IN THE MATTER OF AN APPLICATION TO
AN BORD PLEANÁLA

FOR APPROVAL OF THE FOYNES TO LIMERICK ROAD (INCLUDING
ADARE BYPASS) COMPRISING:

Brief of Evidence

Responses to Submissions on Engineering Issues

Figure 3.1 House at Ardshanbally

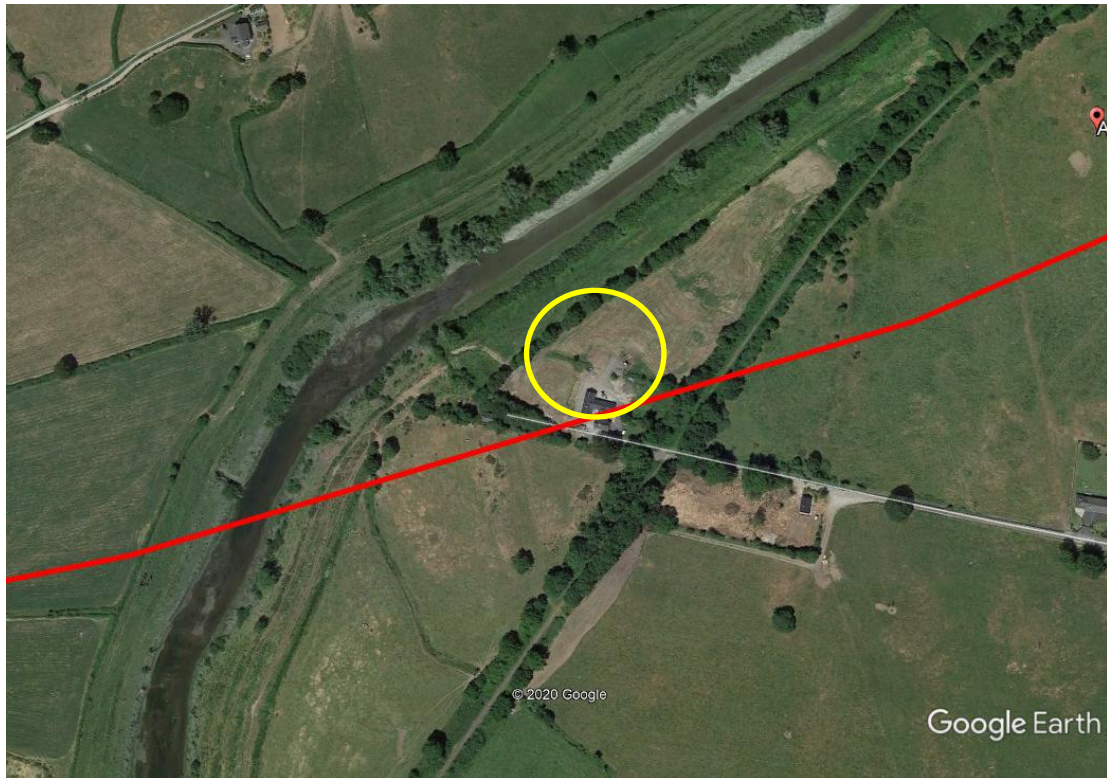
- 3.8. Submission SCH - 34 from Francis and Anne O'Kelly, whose house will be acquired at Ardshanbally (northeast of Adare and just east of the proposed River Maigue bridge crossing), questions what alternative options were considered during the design stage to avoid impacts on residential properties including their property. As there is significant agricultural land either side of the Property, the landowner believes that the route could have been developed outside of their property. The submission requests information to identify what alternative options were considered at the Property and to provide the assessment that formed the basis for discounting all of these other options.

- 3.9. At Ardshanbally there are two major constraints on the proposed road alignment that restricted the possibility of avoiding the O'Kelly house, which is circled in yellow on the image below, with the centreline of the proposed road shown in red. All other things being equal, it would have been desirable to avoid the house if this had been possible. As may be seen on the Google Earth image below in Figure 3.1, the two major physical features at this location are the River Maigue about 100m to the west of the house (on the left), and the Limerick to Foynes Railway line immediately to the east (on the right). A further consideration is the proximity of the proposed connection of the new road to the existing N21 at Clonunion/Monearla 2.3km to the east of the house.

Figure 3.3 Askeaton Roundabout

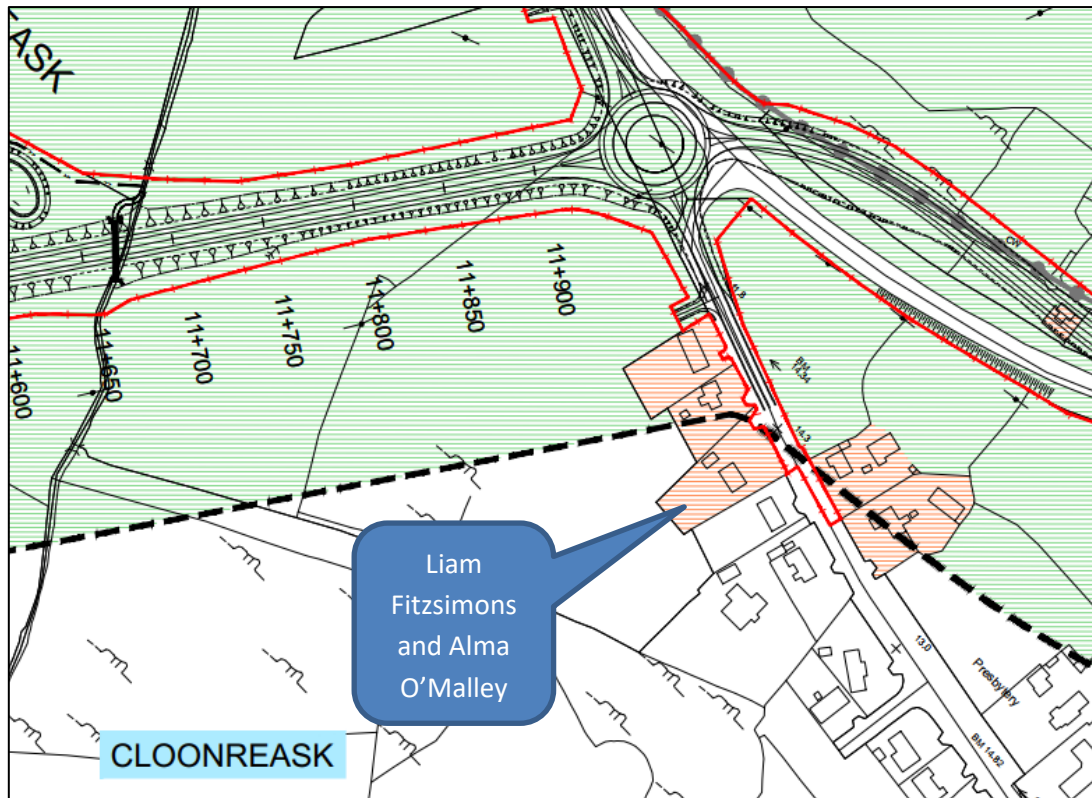
- 3.14. Submission SCH-63 (for Liam Fitzsimons & Alma O’Malley who live on the western side of Askeaton near the proposed roundabout for the new link road) states that there are no details or alternatives provided to the closure of the public road outside of their dwelling house (Plot 219 as shown on Figure 3.3) and no alternatives for public access have been put forward by the County Council.

- 3.15. The R518 public road in front of the property in question will not be closed and access will be maintained during both construction and operation phases. A new roundabout junction will be provided at the existing junction between the R518 and the N69, due west of the property, which will maintain access onto the R518 towards Askeaton as currently exists, while also providing access onto the proposed link road to Ballyclogh and onward towards Foynes and Rathkeale.

Figure 3.4 Proposed Road at Kilknockan

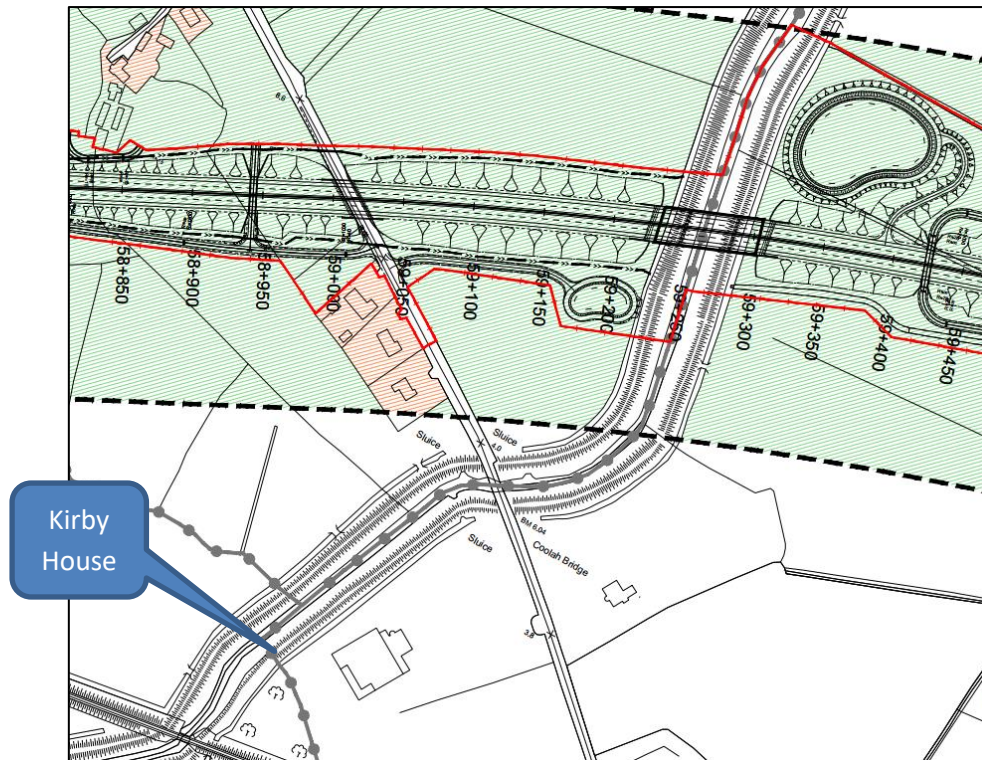
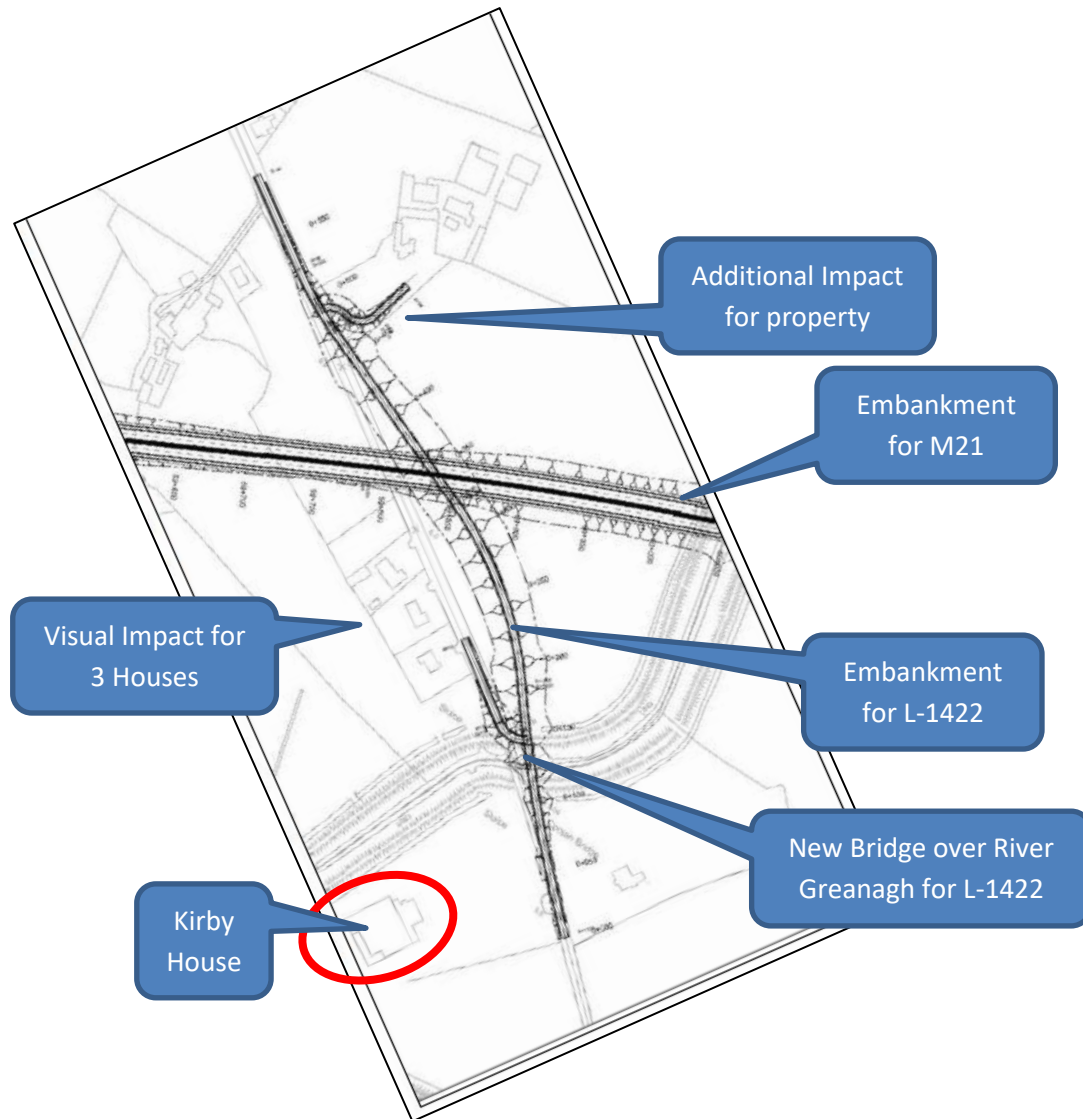
- 3.16. Eamonn & Lorraine Kirby, residents of a house located 300m south of the proposed road (as shown in Figure 3.4), argue that the current design does not provide the optimal design in the Kilnockan area. It is contended that the elevated road embankment will have a *'very real visual intrusion on the landscape'* and a *'significant visual impact on our property and that of our neighbours'*. It is also noted that previous submissions were made by the local residents at the route selection stage of the project and in subsequent liaison with the Limerick County Council's Regional Road Design Office, wherein it was requested that the L-4422 Blackabbey Road be built over the new road to reduce the height of the mainline embankment. An issue was also raised that the clearance over the Greanagh River *"appears to be excessive"* and suggested that it could be significantly reduced.

- 3.17. In Submission ENV-9, it is also argued that the suggested reduction in mainline embankment height “*will also assist from a sustainability point of view in significantly reducing the importation of earthwork fill material required in this area and assist in reducing the substantial deficit of 1.3 million cubic metres of material*”.

- 3.18. The suggested alternative arrangement at Kilknockan was addressed on Page 86 in Chapter 3 of the EIAR as shown in Plate 3.62 which is shown overleaf.

Figure 3.5 Planning Search Map at Gortnagrour

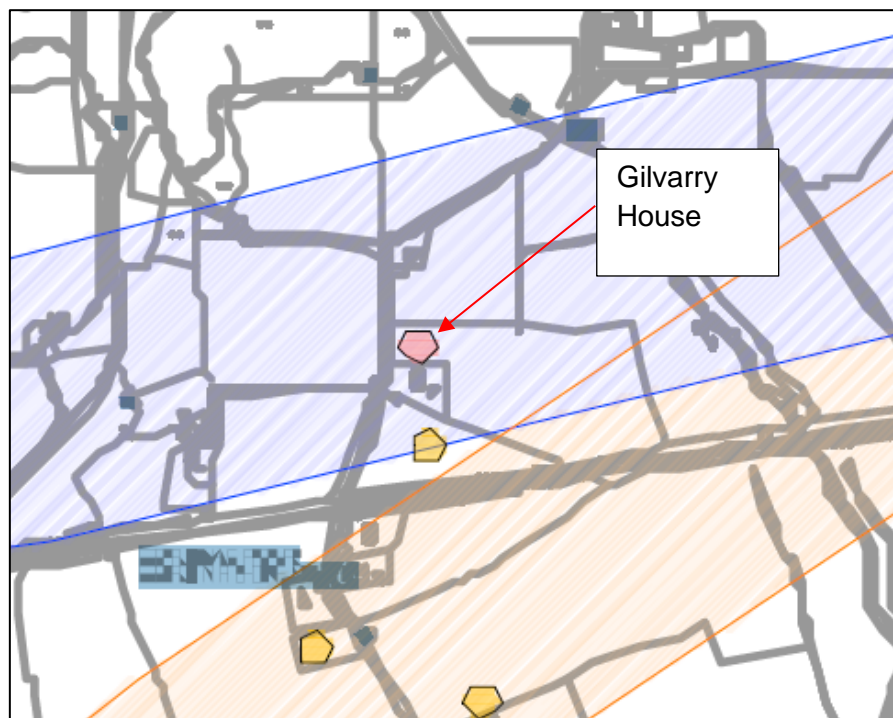
- 3.19. These two submissions from Ian Gilvarry assert that the mapping used during the Route Selection stage was out of date, as it did not include Mr. Gilvarry's house which was granted planning permission in 2008 and which commenced construction in 2010. It is claimed that mapping used during the design phase does not include a house built by his neighbour either. These houses are located about 100m to 200m to the north of the proposed road on the northern side of the railway line.

- 3.20. An examination of the Limerick City and County Council planning lists was undertaken in 2015 as part of the Route Selection process to identify any pending or awarded planning permissions within the study area. These were mapped on Drawing Nos. CS-055 to CS-059 in Volume 2 of the Route Selection Report. As a matter of fact, the property in question is shown as a planning permission in the image below (an extract from the map in the RSR report) and it was, therefore, considered as part of the assessment, despite it not being indicated on the available OS mapping at the time of writing of the Route Selection Report. Accordingly, although the Gilvarry house was not shown on the base OS mapping available at that time, the mapping used in the route selection stage had been modified to indicate the Gilvarry house and all other planning permissions in the vicinity of the corridors, as is shown in Figure 3.5.

Figure 3.6 Proposed Road at Clonshire More

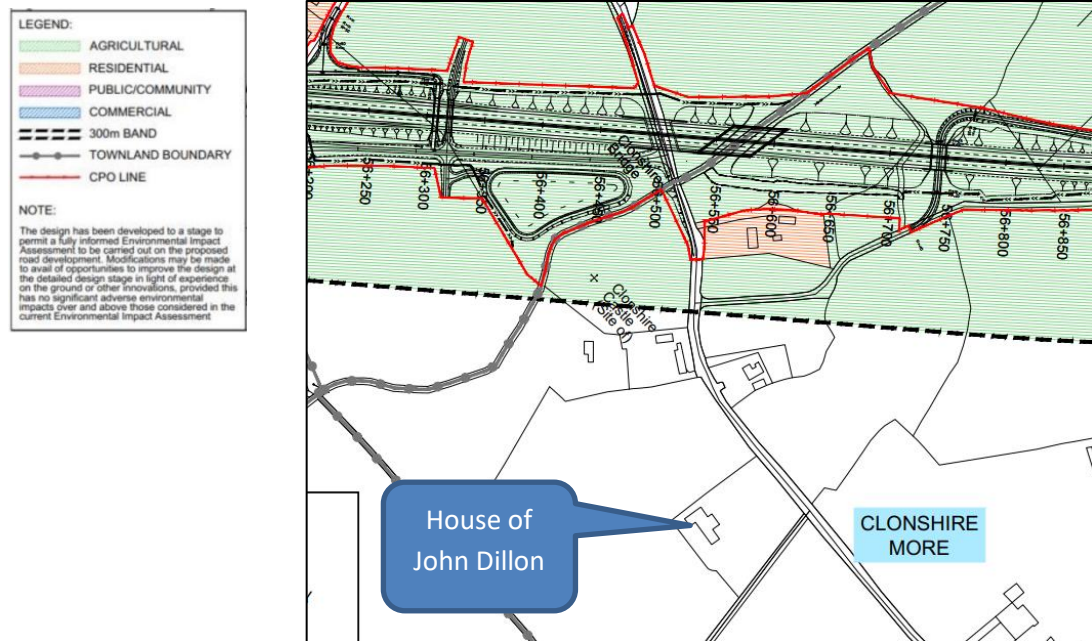
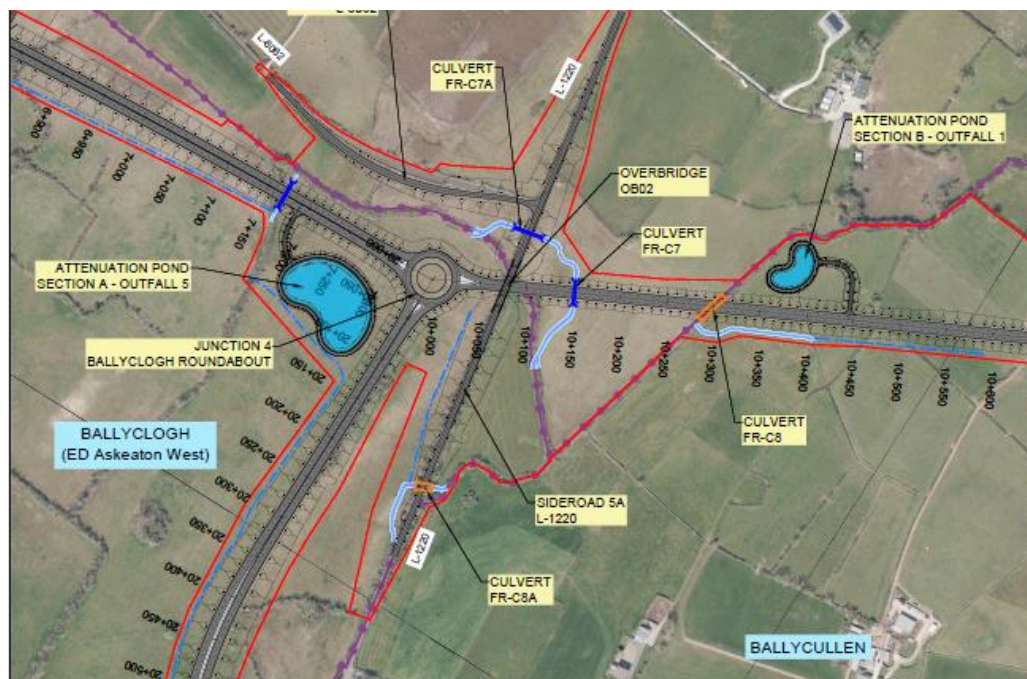
- 3.21. This submission was made on behalf of John Dillon, who lives about 300m to the southeast of the proposed road at Clonshire More as shown in Figure 3.6. The submission suggests that the alternatives are not adequately assessed under a number of headings, particularly, potential visual and noise impacts on this residential property.

- 3.22. Alternative options were assessed in accordance with the applicable guidelines and regulations for proposed road schemes at all stages of the planning process during the period 2014 to 2019 when the EIAR was published. This process has been outlined in Part A of my Brief of Evidence. The considerable distance of the proposed road from the house in question will greatly limit the potential for noise and visual impact, for which this house lay outside the zones of influence for such impacts to require detailed assessments.

Figure 4.3 CPO Map at Corrig, Foynes

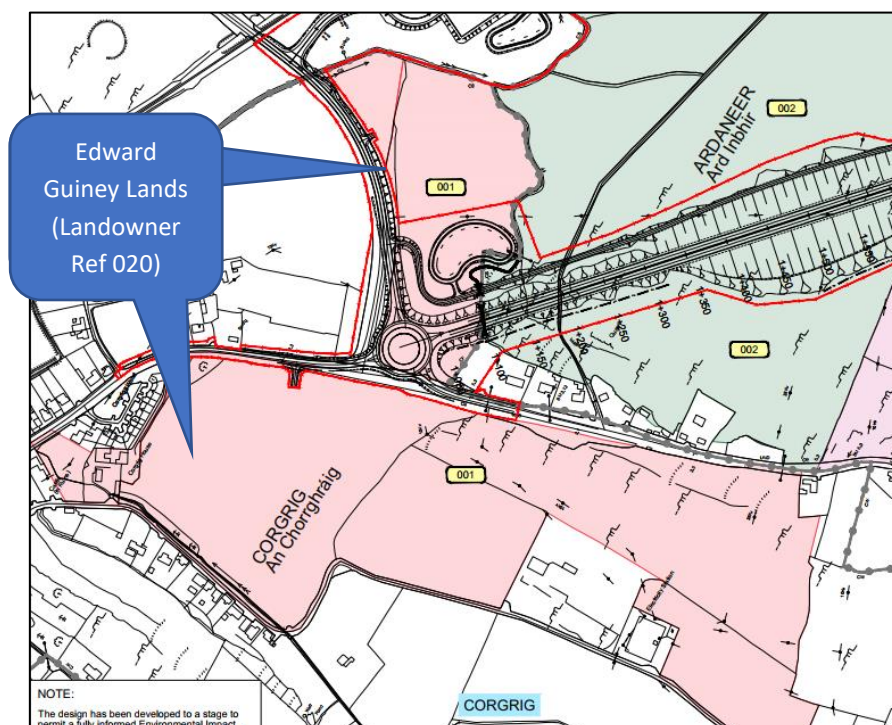
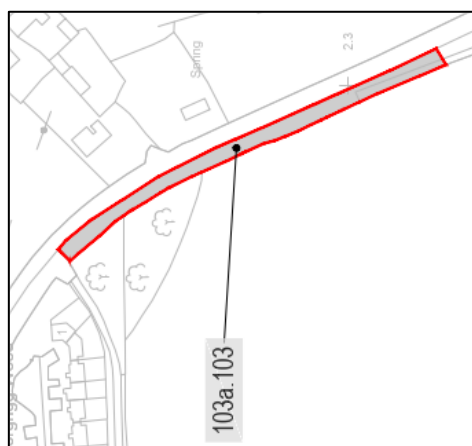
- 4.12. Submission SCH-29 for Edward Guiney of Corrig, Foynes, refers to the lands in Plot 103 that extend along both the existing N69 south of Foynes and along the Foynes Port access road as shown shaded in pink on the map in Figure 4.3. Of these lands Plot 103a.103 is the only area of land to be acquired that has been identified as part of public road.

The folio LK22472 under ownership of Edward Guiney extends to the midpoint of the existing N69. Plot 103a.103 represents the acquisition of this area of public road including the verge strip, as shown in Figure 4.4. There are no areas of curtilage to be acquired within Plot 103a.103. The land-take is clearly marked in the drawings in Volume 3 of the EIAR.

Figure 4.5 CPO Map at Kilgobbin, Adare -James Clarke lands shaded blue

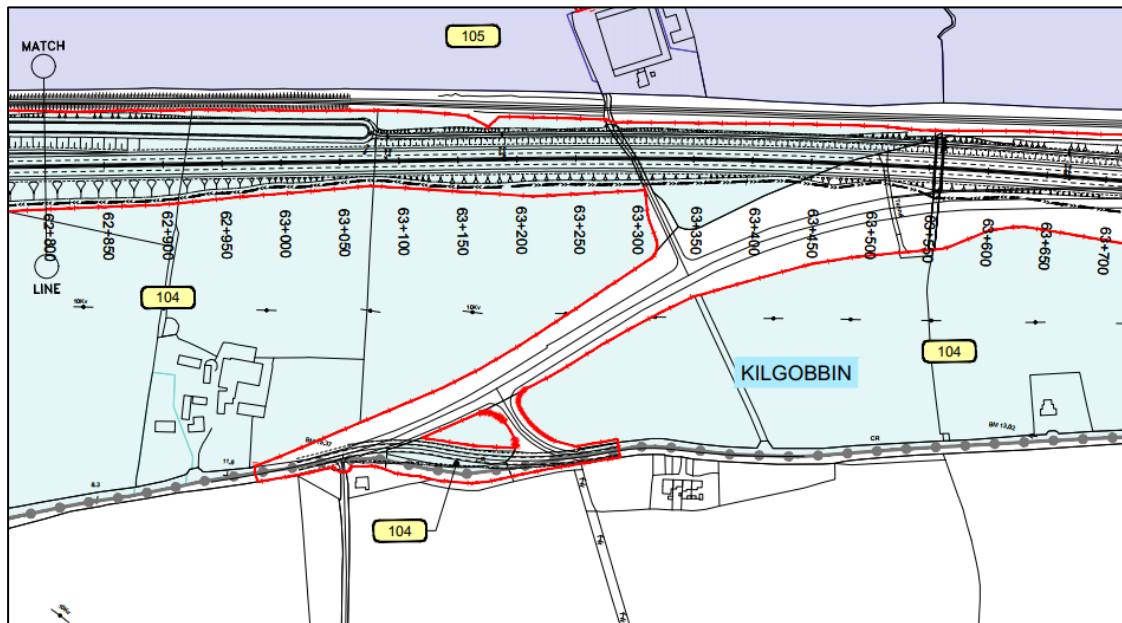
4.13. Submission No.44 on behalf of James Clarke, of Kilgobbin, Adare (Plot No.480) says that the compulsory acquisition schedule is incorrect in identifying the curtilage of the dwelling house as road acquisition.

4.14. The lands in Plot 480 extend along both sides of the existing N21 road and along the southern side of the Limerick to Foynes railway line as shown on the following map in Figure 4.5. There are no areas of curtilage to be acquired within any Landowner 480 Plots.

Figure 4.7 CPO Map at Mulderricksfield

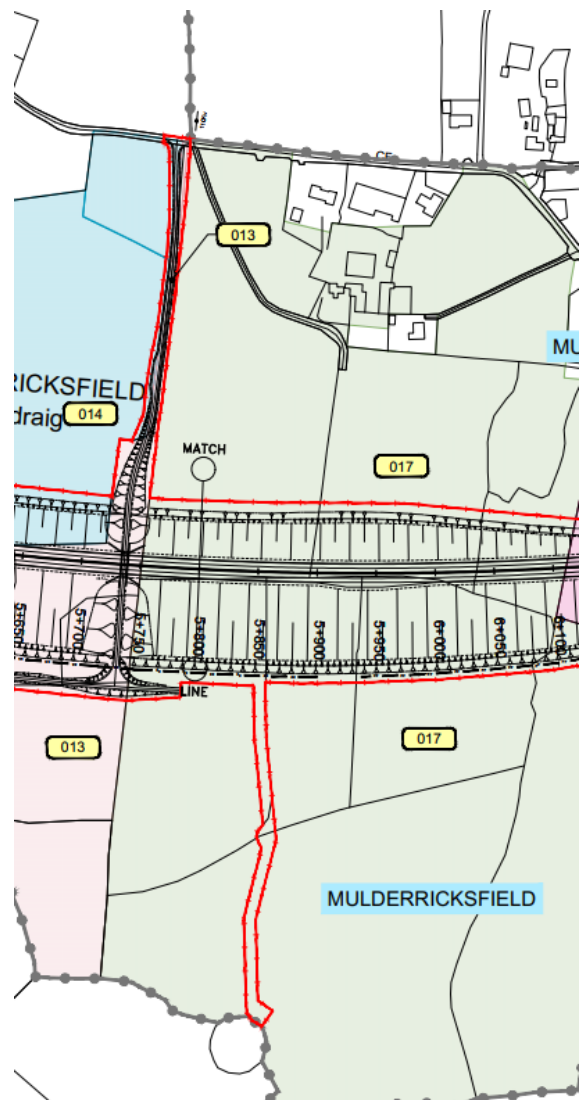
- 4.17. Submission SCH-121 from the Craggs/Barrigone Group Water Scheme Ltd. states that a compulsory acquisition schedules have not been issued to land owners in the vicinity of the existing source well and that LCCC needs to identify an area for a new bore hole.
- 4.18. The Group Water Scheme has also requested to be named in the compulsory acquisition schedules for the lands to be acquired at Mulderricksfield for the provision of a new connection from the public water supply scheme to the existing group scheme reservoir as shown in Figure 4.7. on the basis of their ownership of the existing water scheme infrastructure in this location.

- 4.19. The compulsory acquisition schedule has been updated for consideration by the Board to include the Craggs/Barrigone Group Water Scheme Ltd. as having an interest in lands traversed by the water supply scheme infrastructure.

- 4.20. Additional lands do not need to be acquired for the provision of a possible new borehole for this water supply scheme in the highly unlikely event that one might be required, as such works would be undertaken by agreement and would remain under the current ownership and control of the group water scheme.
